# NIAGARA MOHAWK POWER CORPORATION

# NINE MILE POINT NUCLEAR STATION, UNIT 2

## AMENDMENT TO FACILITY OPERATING LICENSE

Amendment No. 26 License No. NPF-69

FIGURE 3.4.6.1-1

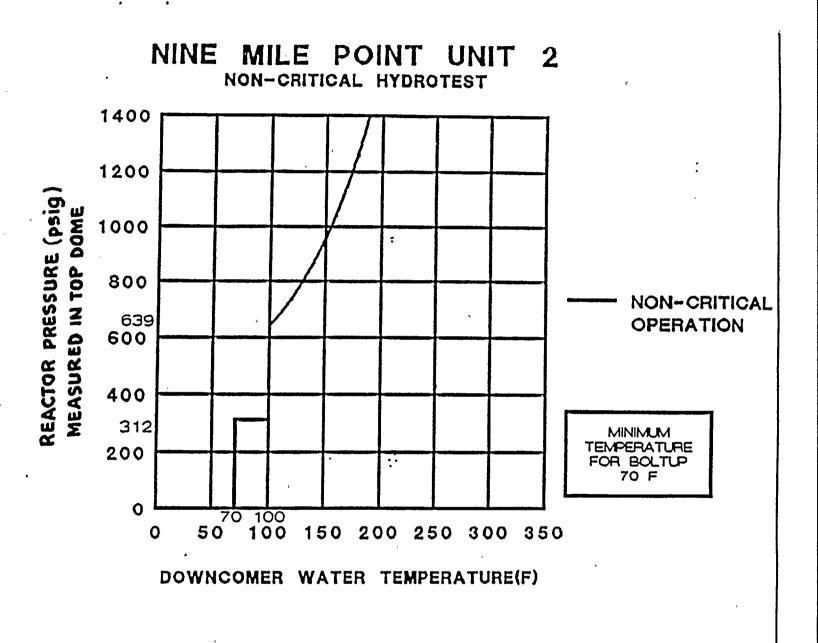
3.4.6.1 The reactor coolant system temperature and pressure shall be limited in accordance with the limit lines shown on Figure 3.4.6.1-1 for hydrostatic or leak testing; Figure 3.4.6.1-2 for heatup by non-nuclear means, Figure 3.4.6.1-3 for cooldown following a nuclear shutdown and low-power PHYSICS TESTS; and Figures 3.4.6.1-4 and 3.4.6.1-5 for operations with a critical core other than low-power PHYSICS TESTS, with:

4.4.6.1.3 The reactor vessel material surveillance specimens shall be removed and examined to determine changes in reactor pressure vessel material properties as required by 10CFR50, Appendix H, in accordance with the schedule in Table 4.4.6.1.3-1. The results of these examinations shall be used to bring up to date the curves of Figures 3.4.6.1-1, 3.4.6.1-2, 3.4.6.1-3, 3.4.6.1-4 and 3.4.6.1-5.

FIGURE 3.4.6.1-4

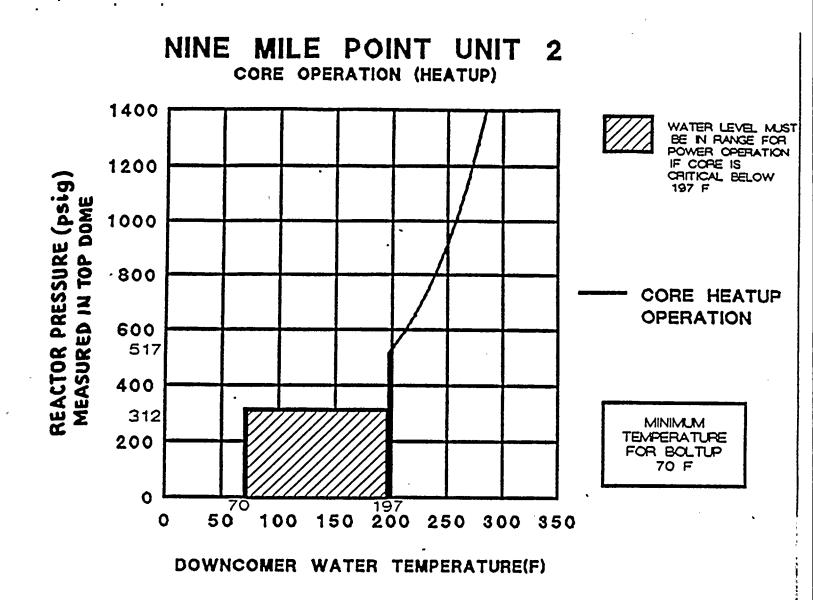
4.4.6.1.2 The reactor coolant system temperature and pressure shall be determined to be to the right of the criticality limit line of Figures 3.4.6.1-4 and 3.4.6.1-5 within 15 minutes before the withdrawal of control rods to bring the reactor to criticality and at least once per 30 minutes during system heatup.

Provided the water level is in the range for power operation, the core may be critical when left of the criticality limit line if the pressure is maintained below 312 psig (see cross-hatched region in Figures 3.4.6.1-4 and 3.4.6.1-5). In this case, the reactor coolant temperature and pressure shall be determined to be within the cross-hatched region of figures 3.4.6.1-4 and 3.4.6.1-5 within 15 minutes before withdrawal of control rods to bring the reactor to criticality and at least once per 30 minutes during system heatup.
